10/13/95	ADDENDUM 1
DATE	REVISION
STATE OF HAWAII DEPARTMENT OF TRANSPORTATION HIGHWAYS DIVISION ROOF WALKWAYS COMMON WORK H-3 FINISH (UNIT III) FAIP NO. I-H3-1(75), UNIT III T.K. TUNNEL/ACCESS ROADS SCALE: 1" = 20' DATE: JUN 1995	
SHEET NO. 7A1	OF 5 SHEETS

STATE OF HAWAII
DEPARTMENT OF TRANSPORTATION
HIGHWAYS DIVISION
**ACCESS OPENING SAFETY
RAILING — HALAWA**
COMMON WORK
H-3 FINISH (UNIT III)
FAIP NO. I-H3-I(75), UNIT III
T.K. TUNNEL/ACCESS ROADS
SCALE: NONE
DATE: JUN 1995
SHEET NO. 7SI OF 6 SHEETS

POTABLE WATER TANK

THIS WORK WAS PREPARED BY ME
OR UNDER MY SUPERVISION

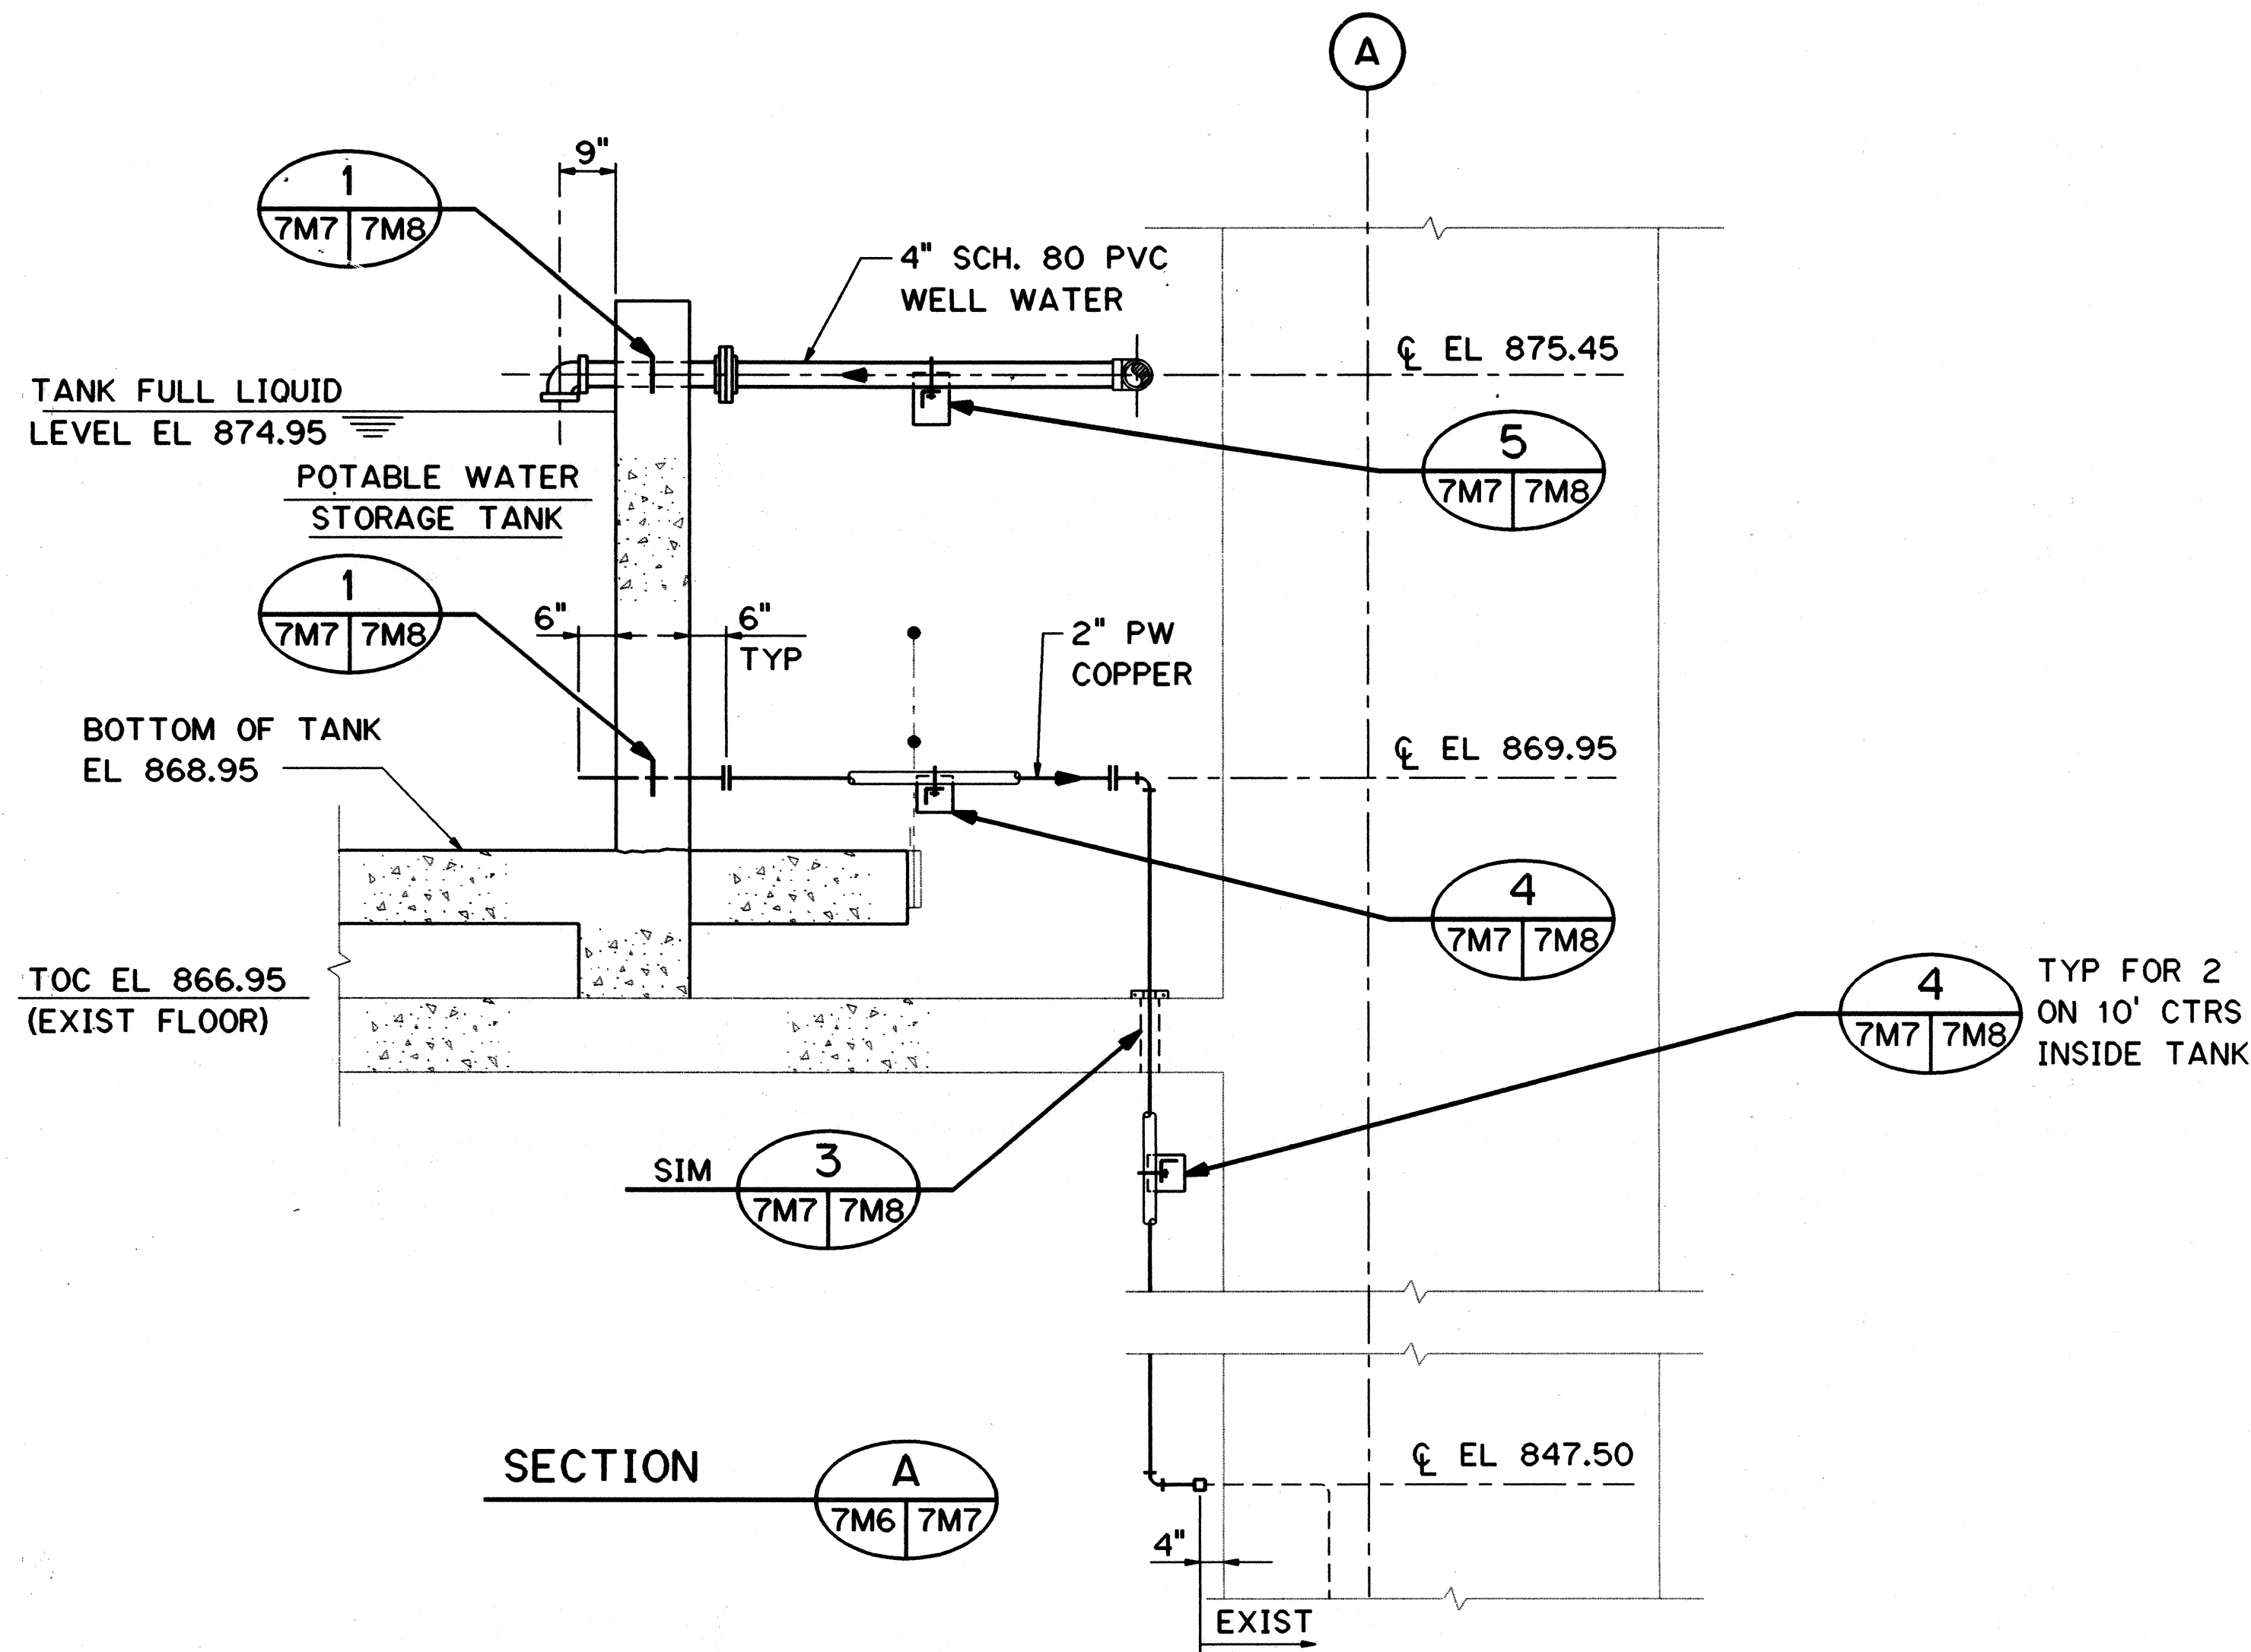
10/27/95	ADDENDUM 2-CHANGED PIPE SUPT. DETAIL 1 SIM. TO DETAIL 5 IN SECT. B
DATE	REVISION
STATE OF HAWAII DEPARTMENT OF TRANSPORTATION HIGHWAYS DIVISION HAIKU POTABLE WATER TREATMENT - SECTIONS COMMON WORK H-3 FINISH (UNIT III) FAIP NO. I-H3-1(75), UNIT III T.K. TUNNEL/ACCESS ROADS SCALE: 1/2" = 1'-0" DATE: JUN 1995	
SHEET NO. 7M7	OF 16 SHEETS

LEVEL SWITCH AND ALARM
MOUNTING DETAIL

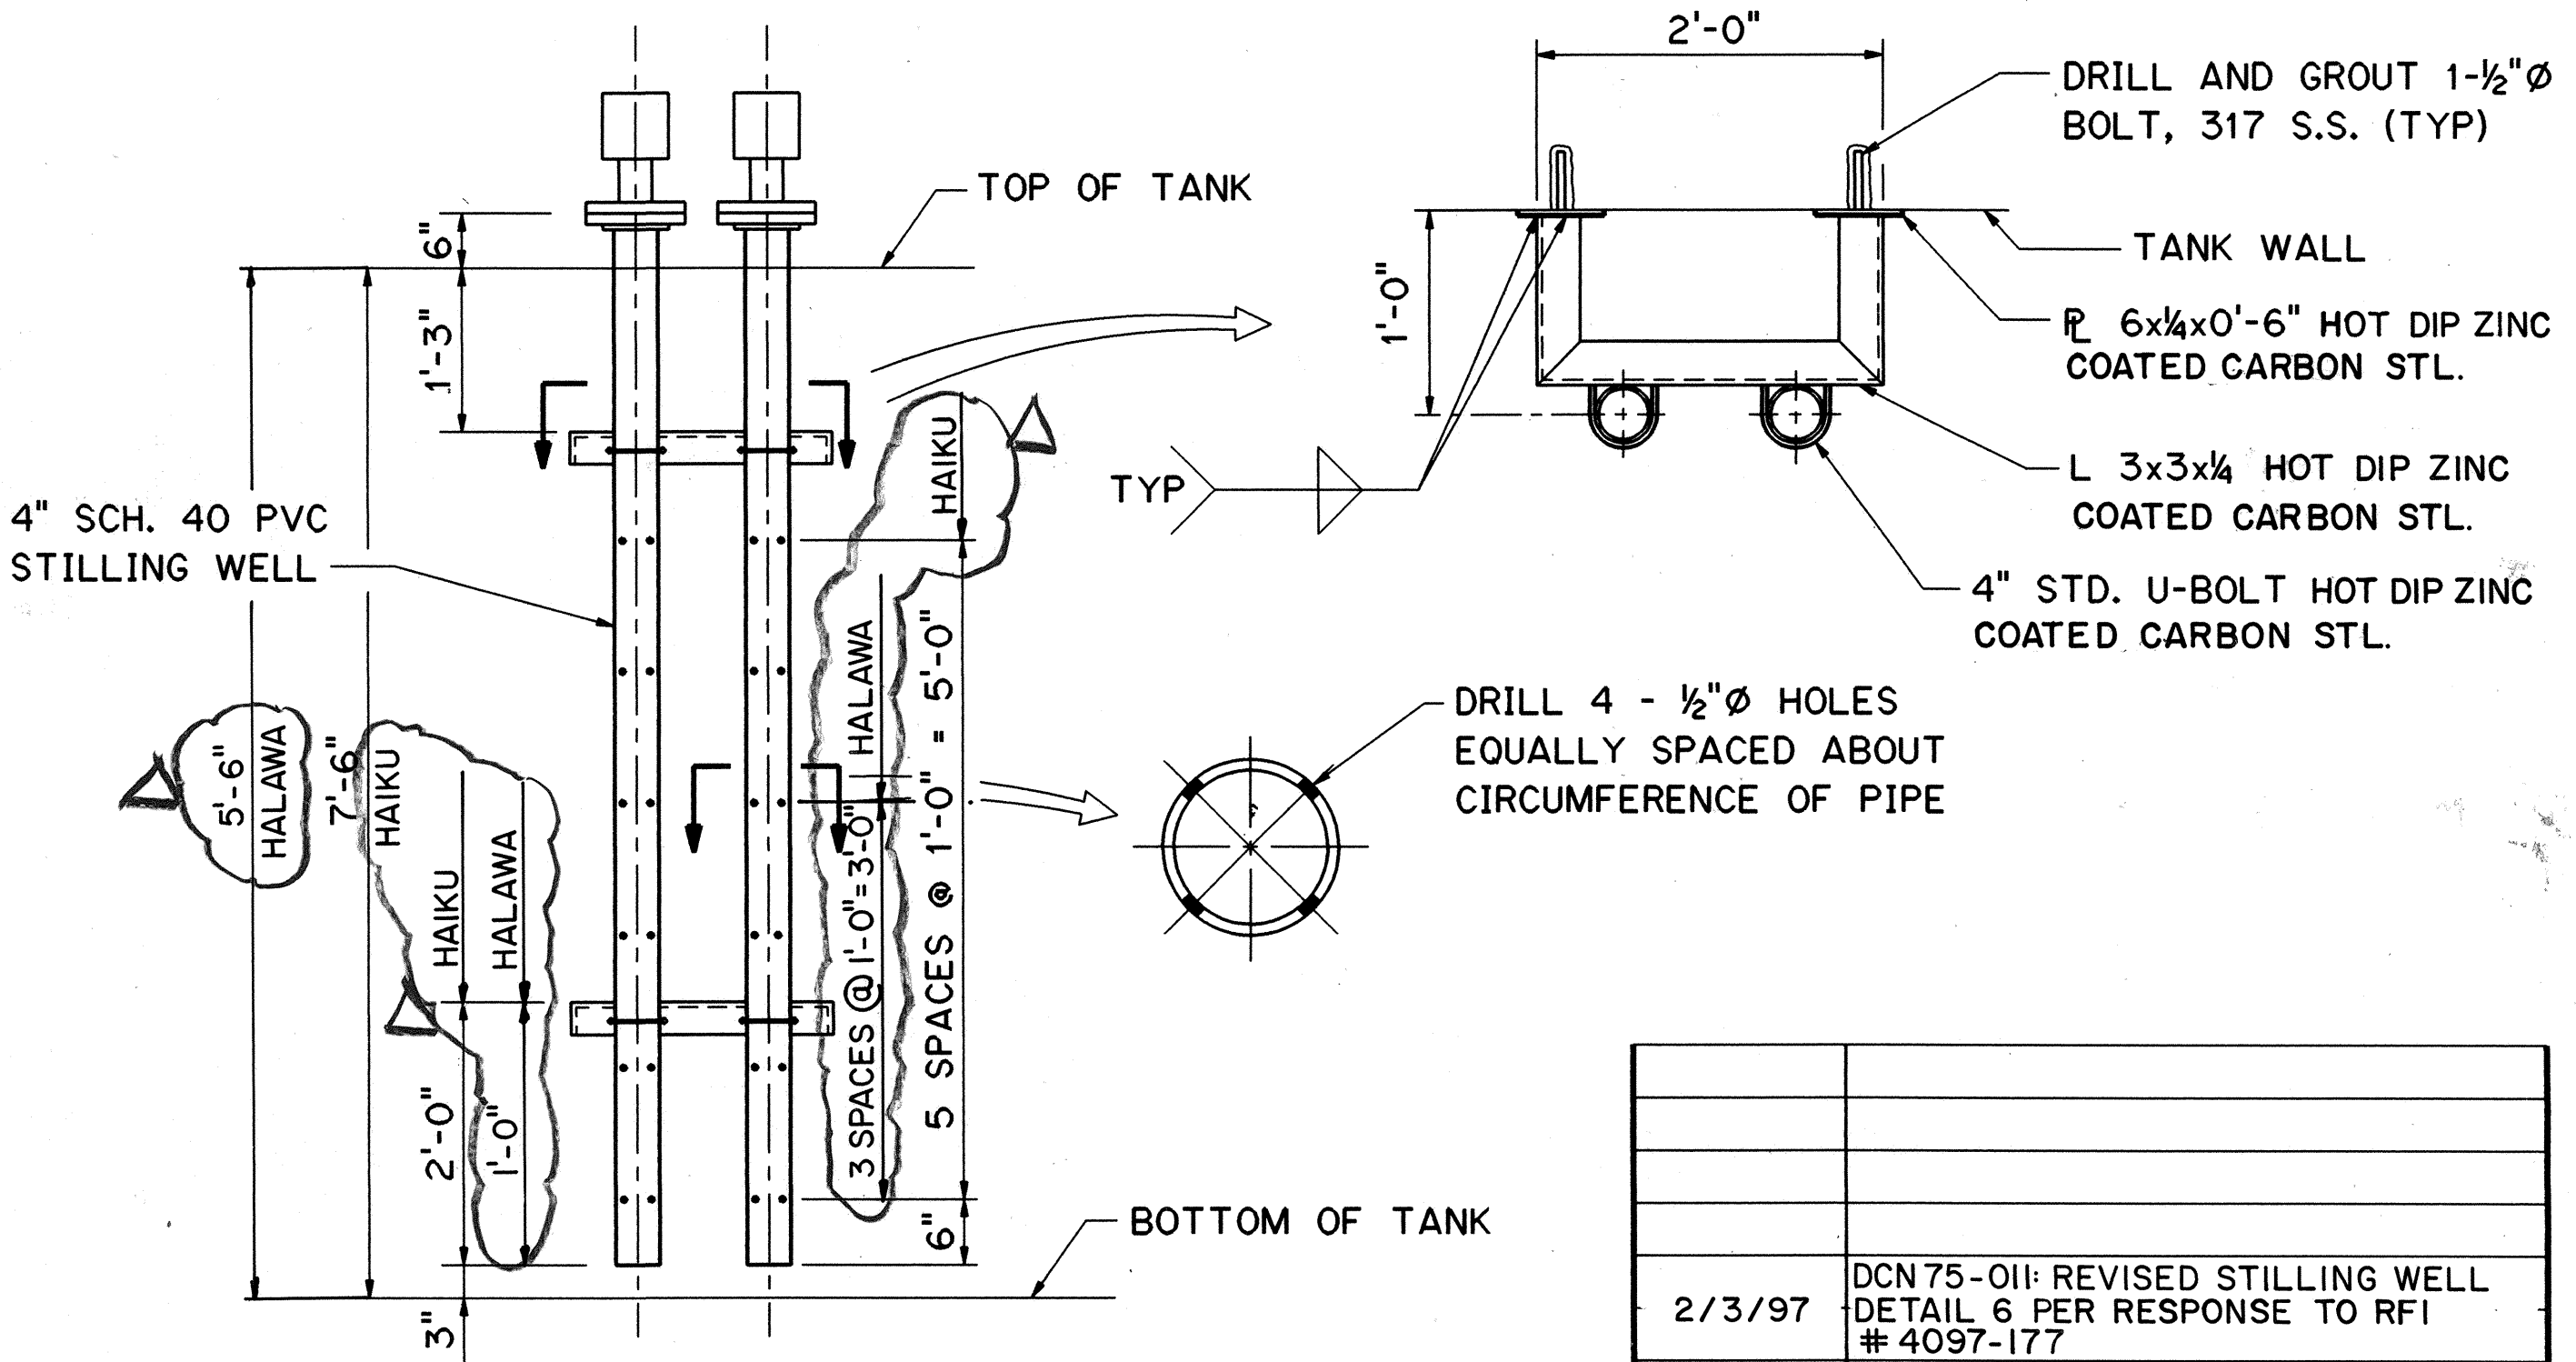
DATE	REVISION
2/3/97	DCN 75-011: REVISED STILLING WELL DETAIL 6 PER RESPONSE TO RF1 #4097-177
10/13/95	ADDENDUM I
DEPARTMENT OF TRANSPORTATION HIGHWAYS DIVISION POTABLE WATER TREATMENT - DETAILS 1 COMMON WORK H-3 FINISH (UNIT III) FAIP NO. I-H3-1(75), UNIT III T.K. TUNNEL/ACCESS ROADS SCALE: AS SHOWN DATE: JUN 1994 SHEET NO. 7M8 OF 16 SHEETS

SECTION B
SCALE: 1/2" = 1'-0"

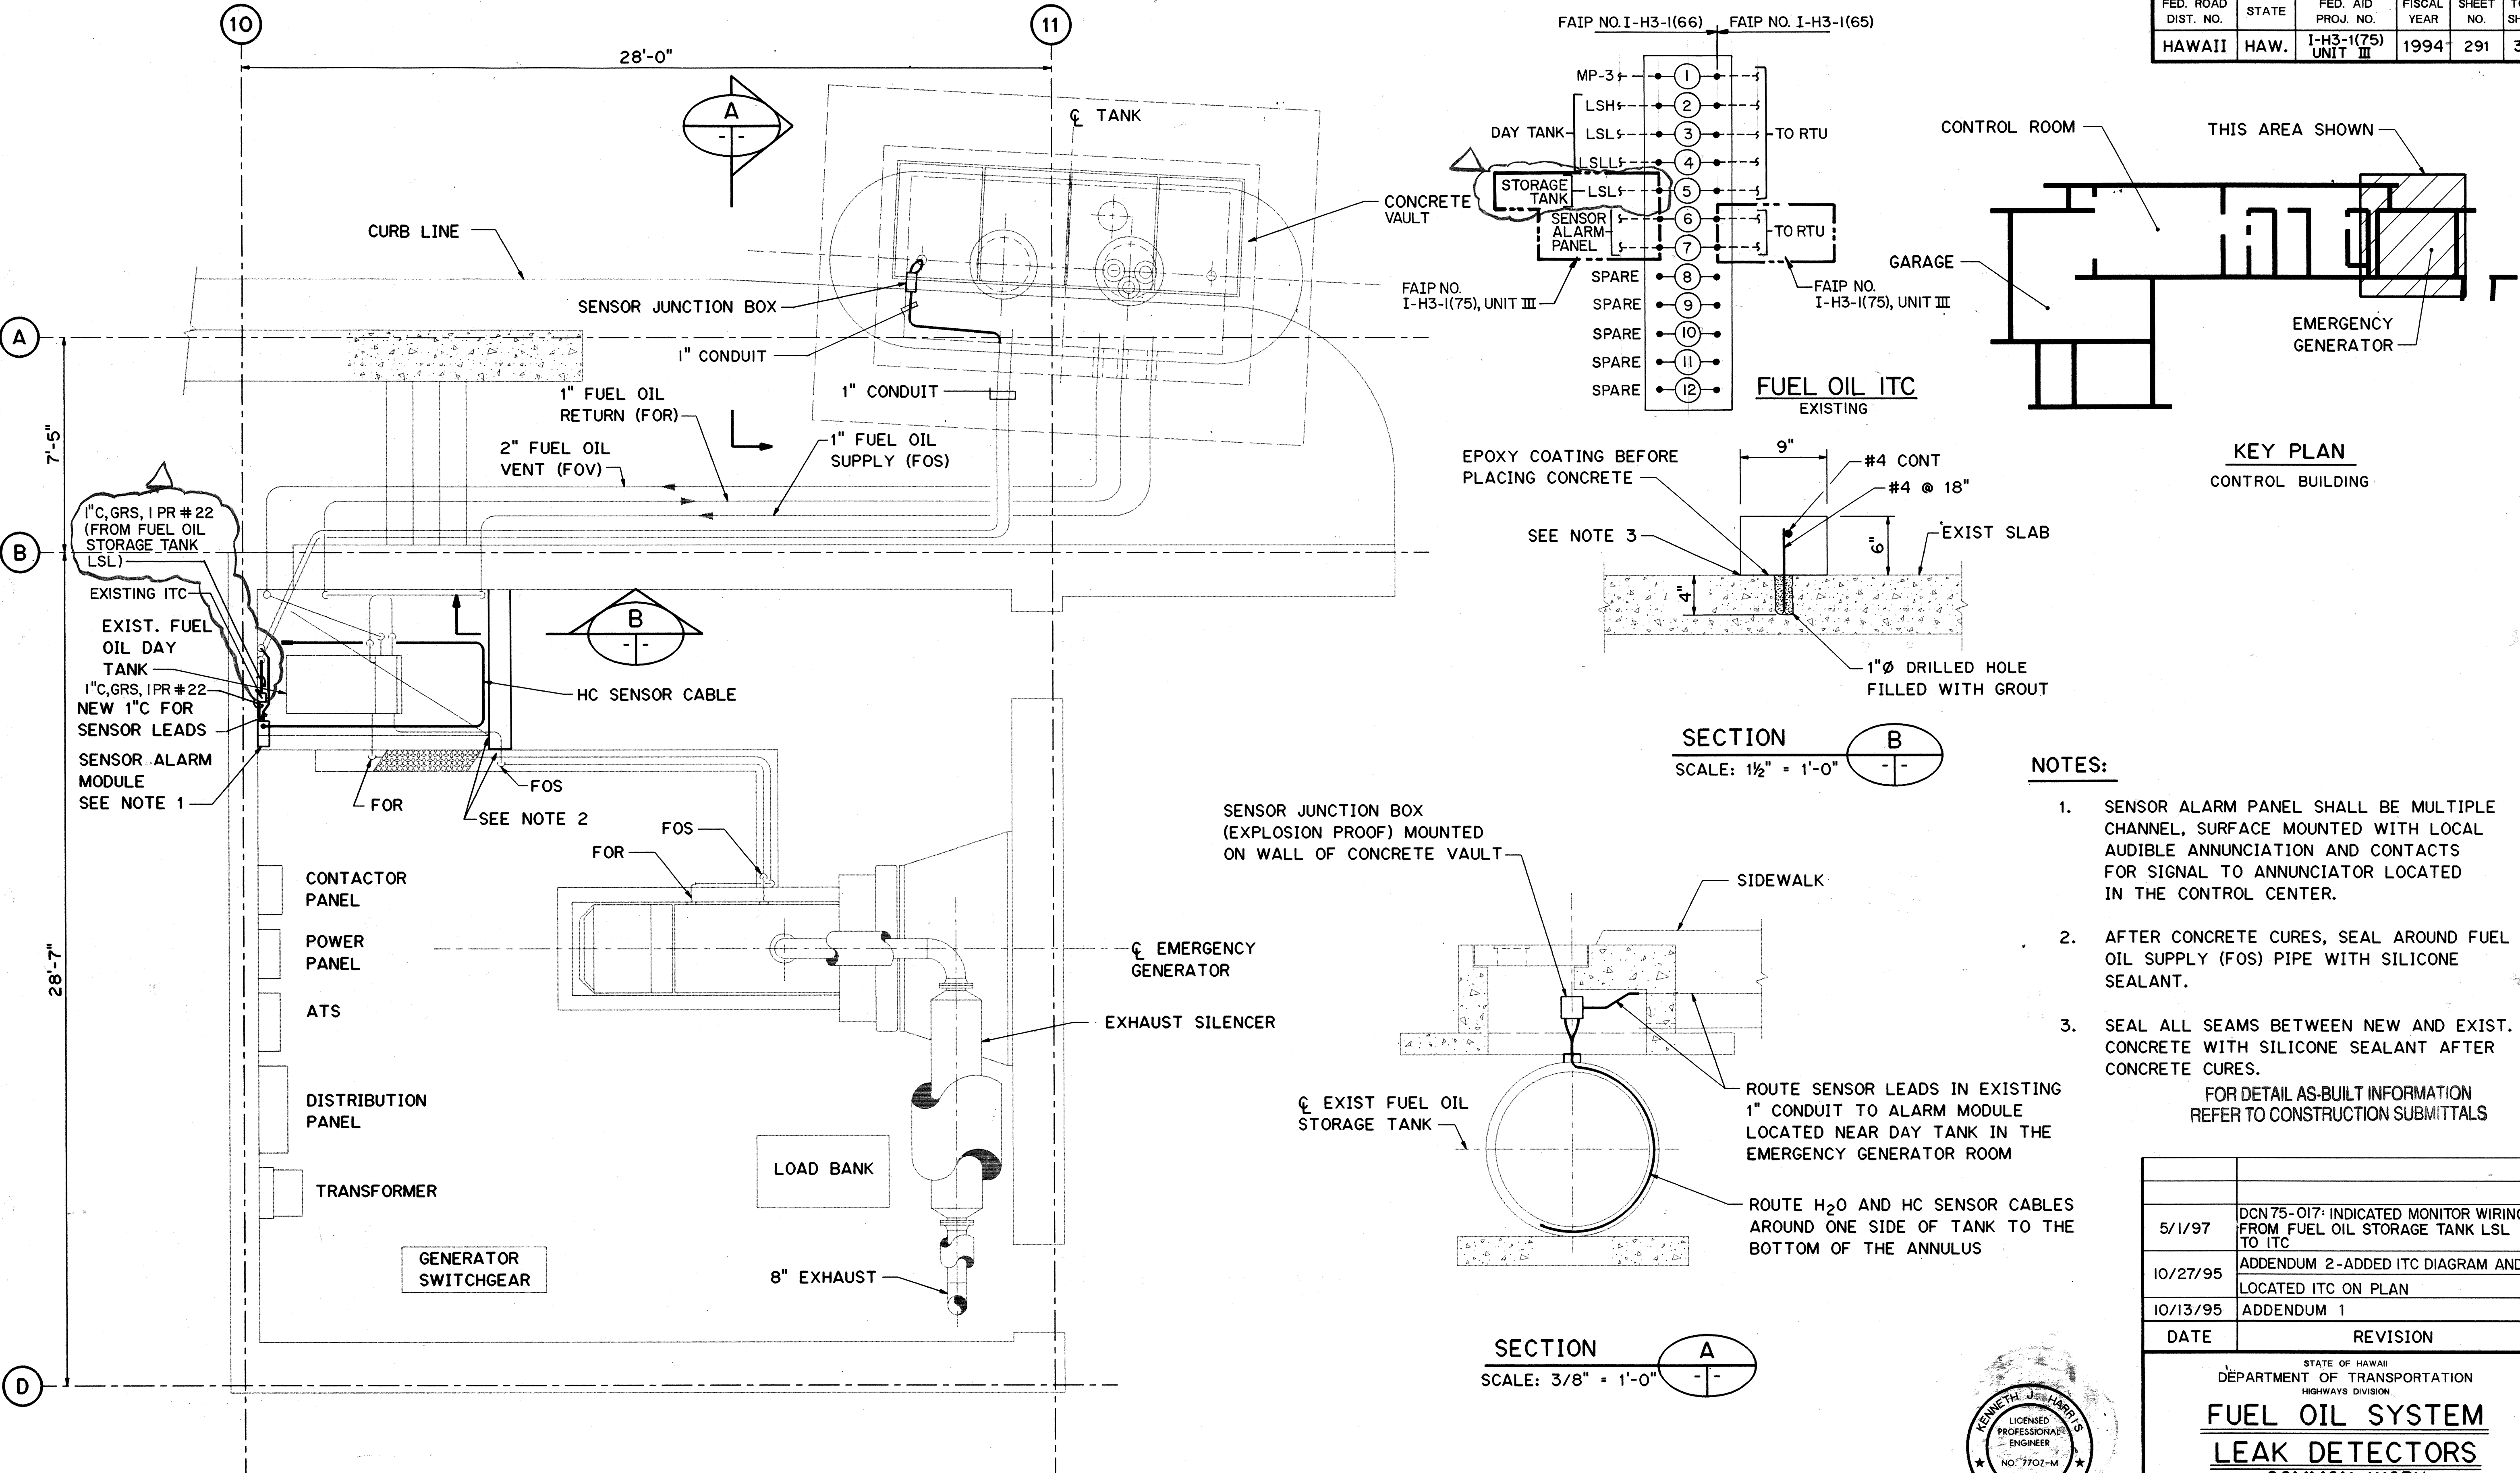
DATE	REVISION
5/1/97	DCN 75-017: INDICATED MONITOR WIRING FROM FUEL OIL STORAGE TANK LSL TO ITC
10/27/95	ADDENDUM 2-ADDED ITC DIAGRAM AND LOCATED ITC ON PLAN
10/13/95	ADDENDUM 1
